## ADMINISTRATIVE REPORT

**Title:** DAV 23-124387\C – 660 Gertrude Avenue

**Issue:** For Variances associated with the establishment of a multi-family dwelling containing six (6) units.

Date: Monday, March 27, 2023  
File No. DAV 23-124387\C

**1 SITE PLAN** 1/8" = 1'-0"

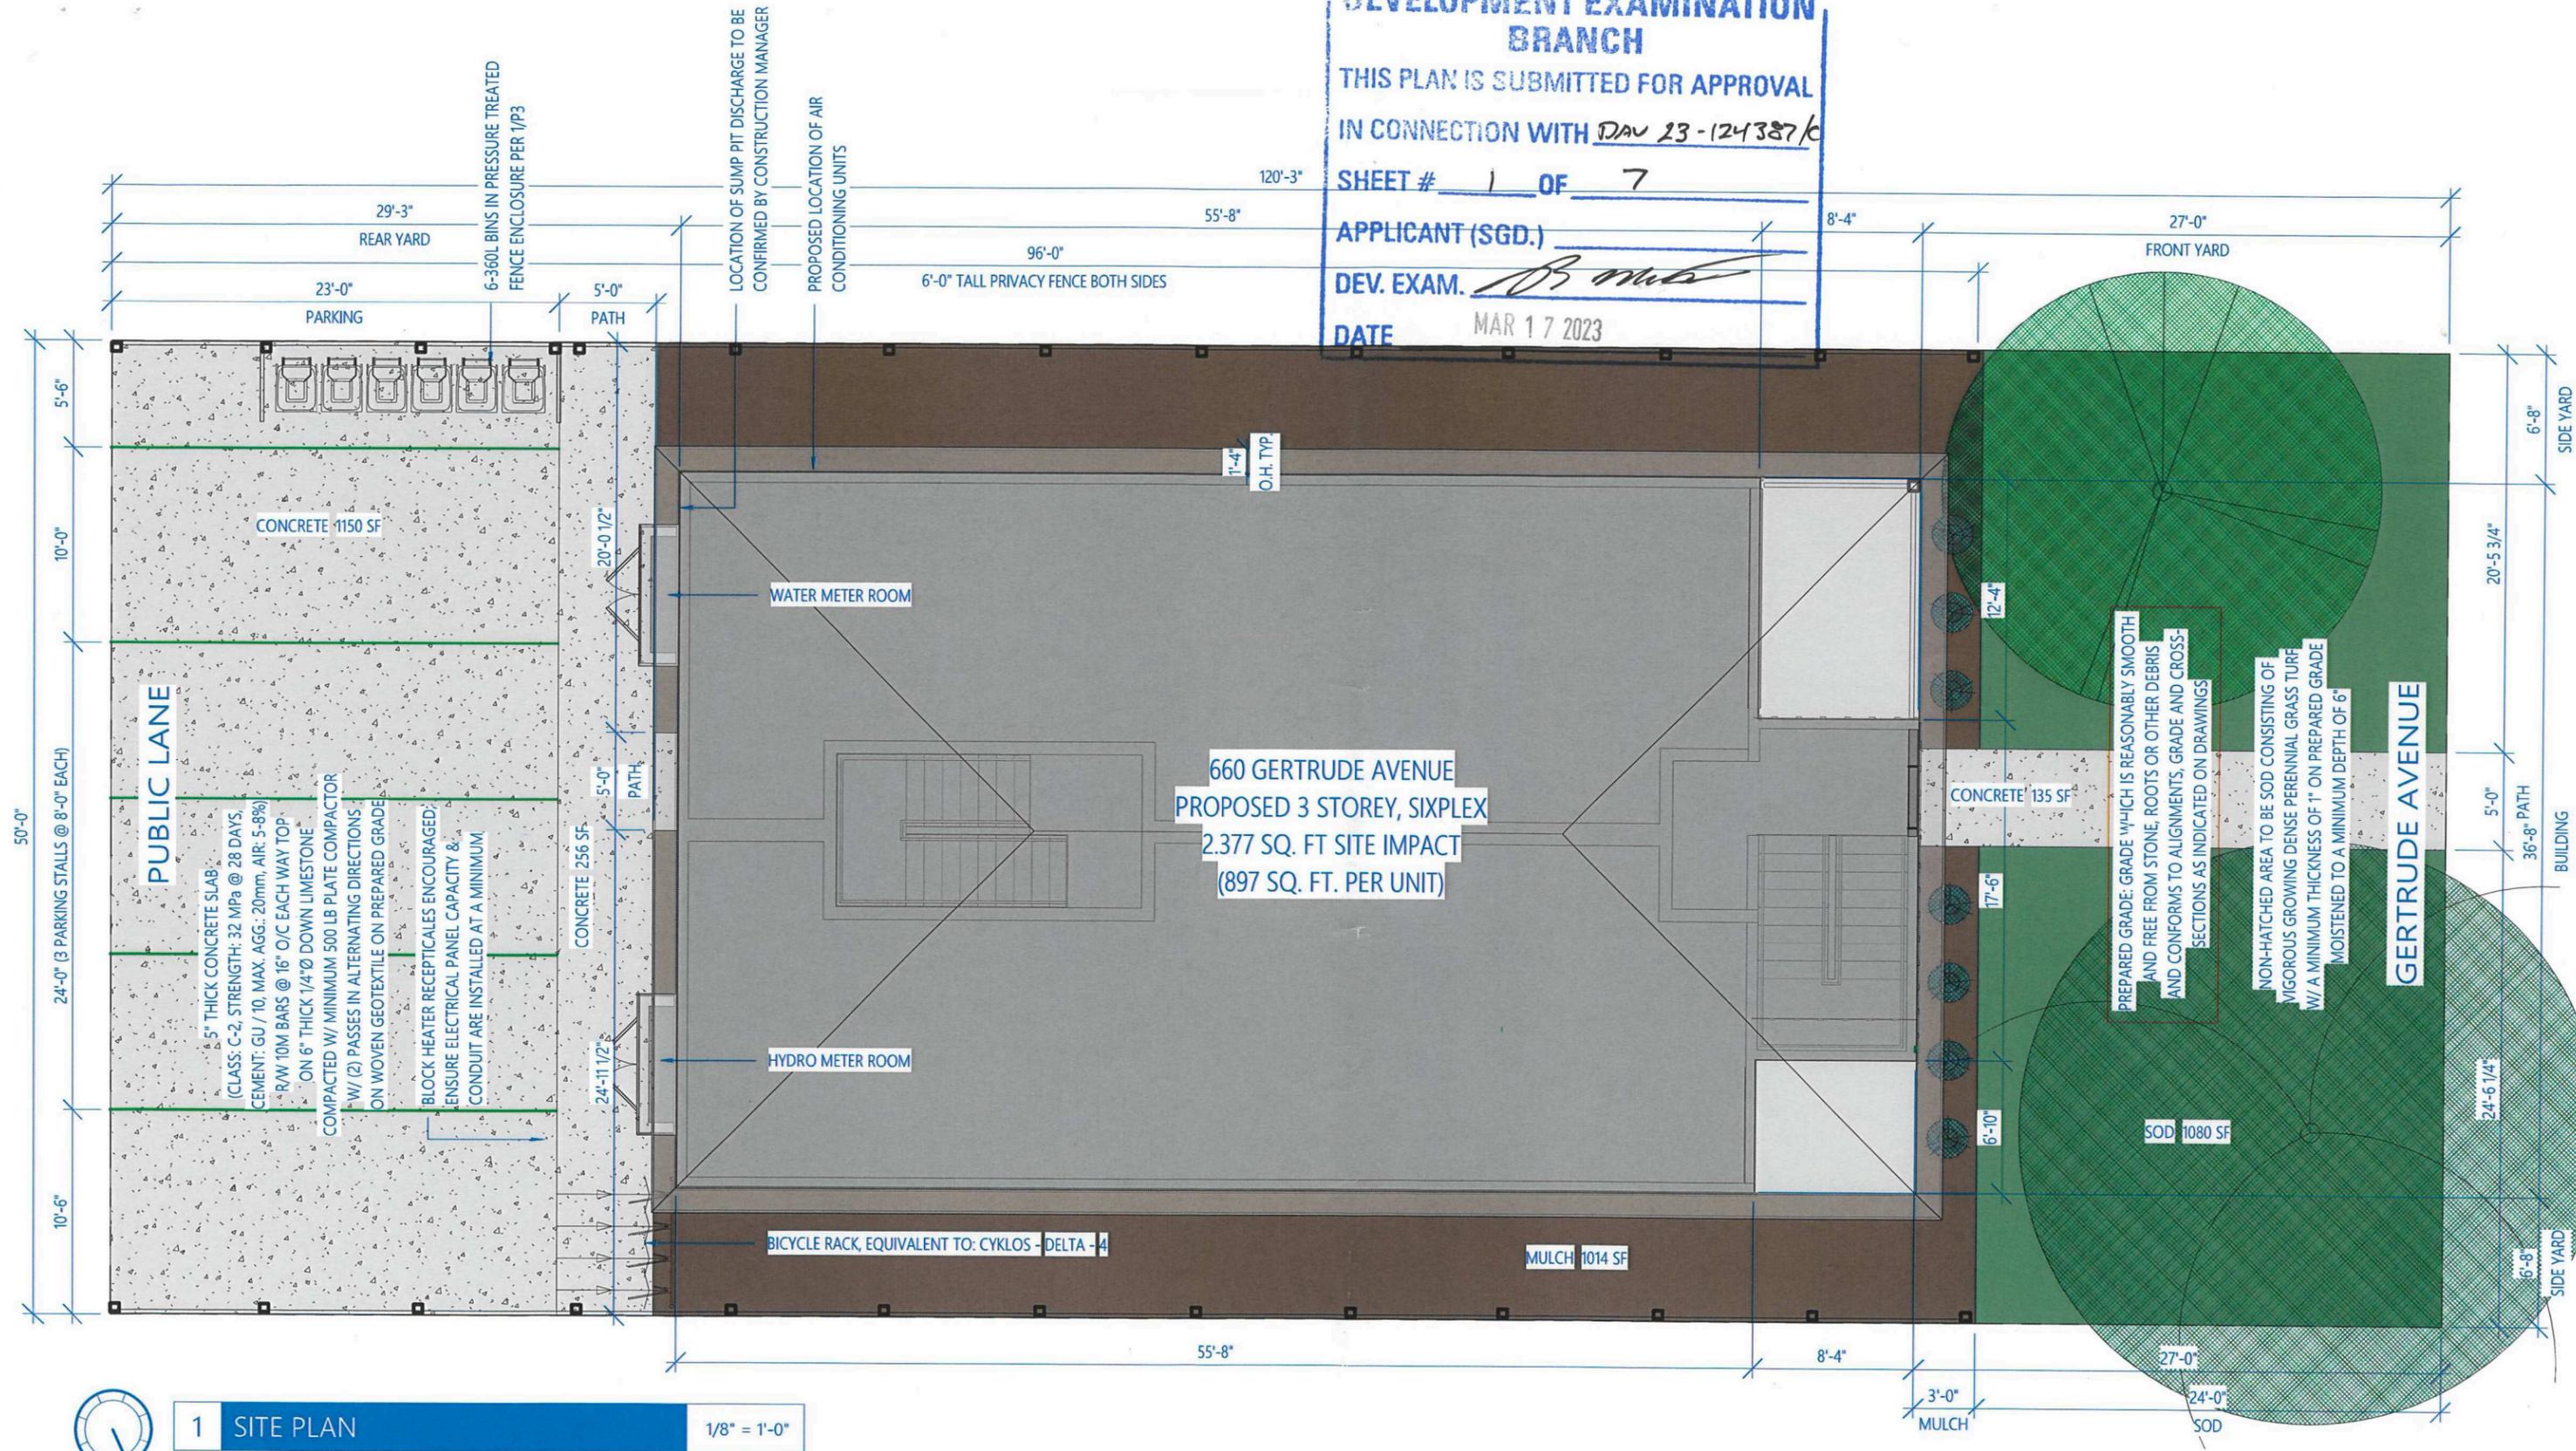
- The proposed front yard is within 5 feet of the average of the abutting buildings.
- The proposed main entrance is located at grade, on the front elevation, and is clearly visible from and connected to the public sidewalk.
- The development provides landscaping and bike parking in exceedance of the minimum requirement of the Zoning By-law.
- The development proposed balconies and decks for each unit.
- The dwelling has a pitched roofline, consistent with the surrounding rooflines on the block.
- High quality materials such as board and batten and lap siding are shown on the front elevation, as well as glazing covering 37% of the front façade.
- Parking is located off the lane behind the dwelling, screened by wooden privacy fence.

A variance is being requested for the construction of multi-family dwelling to permit 5 parking spaces instead of 7 parking spaces. For 6 dwelling units at a rate of 1.2 stalls per unit, 7 units is required. This variance proposes a ratio of 0.83 stalls per unit. The proposal includes visitor bicycle parking for 4 bikes in exceedance of the Zoning By-law requirement (only one is required).

A variance has been requested for insufficient buffering of parking area located within 20 feet (6.1 metres) of a side or rear lot line abutting or adjacent to a residential zoning district. The Winnipeg Zoning By-law requires that a landscaped buffer must be installed when a parking or loading area accessory to any use, other than a single- or two-family residential use, is located within 20 feet of a side or rear lot line abutting or adjacent to a residential zoning district. Since the parking spaces are proposed off the lane, as supported by *CCDS 2.0*, it would not be feasible to have this buffer along the rear property line as this would block cars from entering the parking spaces and they would have to drive over landscaping to access the stalls.

1. for the construction of multi-family dwelling to permit 5 parking spaces instead of 7 parking spaces.
2. for the establishment of a parking area to permit an insufficient landscaped buffer of a parking area located within 20 feet (6.1 metres) of a side or rear lot line abutting or adjacent to a residential zoning district.

1. That prior to the issuance of building permits, the applicant provides the City with written confirmation of a certified arborist hired to provide tree protection oversight of Trees #1 and #4 through demolition and construction in accordance with the submitted arborist report, to the satisfaction of the Director of Planning, Property, and Development.

1 SITE PLAN

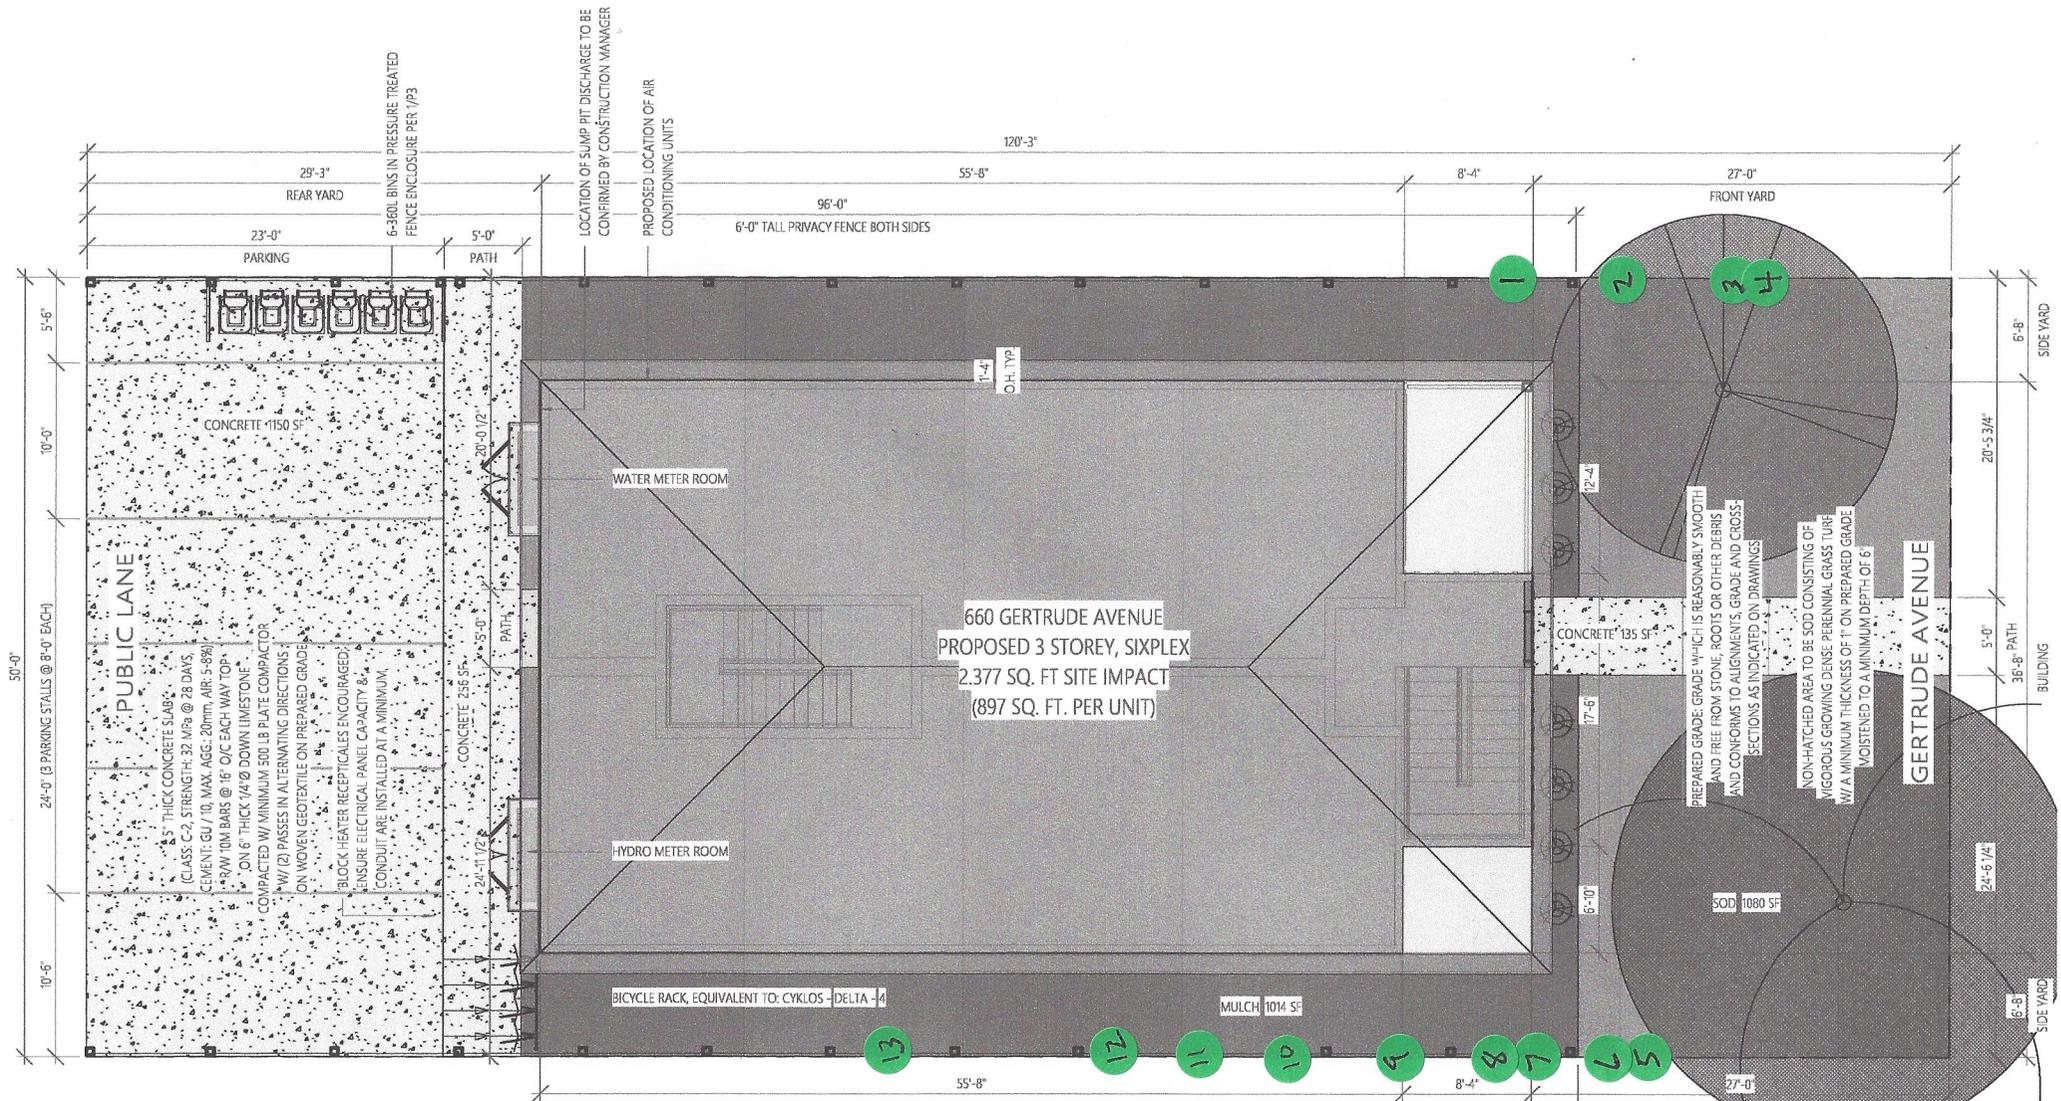
1. Manitoba Maple, multistem 27/19/19cm DBHs, Good condition
2. Green Ash, 21/11/14cm DBHs, Average condition, will be killed by Emerald Ash Borer. Remove

3. Green Ash, 15cm DBHs, Good Condition, will be killed by Emerald Ash borer. Remove
4. Manitoba Maple, 22cm DBH, Good condition
5. Manitoba Maple, multistem 17/19/19/23cm DBHs, Fair condition. Included bark present

The trees growing along the East property line (trees 5-13) are volunteer trees growing into/through an old fence. They all have defects low in the trunks from their interaction with the wire of the fence. These defects could pose a hazard in the future. They may need to be removed to construct the proposed fence on the property line. I have recommended removal of the Ash trees due to the threat from the Ash Borer and the fact that it will be easier to remove them now rather than once the new structure is completed. I do not feel that the construction of the new building requires the removal of the other trees except to prevent future issues and /or for the installation of the fence.

Construction access to the site should be from the back of the property.

Create a Tree Protection Zone (TPZ) around each tree to be retained using the chart below to establish minimum size. Dig as far as practical from the tree trunks to preserve as much of the root system as possible

Physical barriers should be erected to exclude all materials and equipment from the critical root zone (TPZ) and all efforts should be made to avoid compaction and root disturbance outside this zone in order give the tree the best chance for a positive outcome. Trees to be retained should have boards attached to the trunks to avoid accidental damage to the trunks.
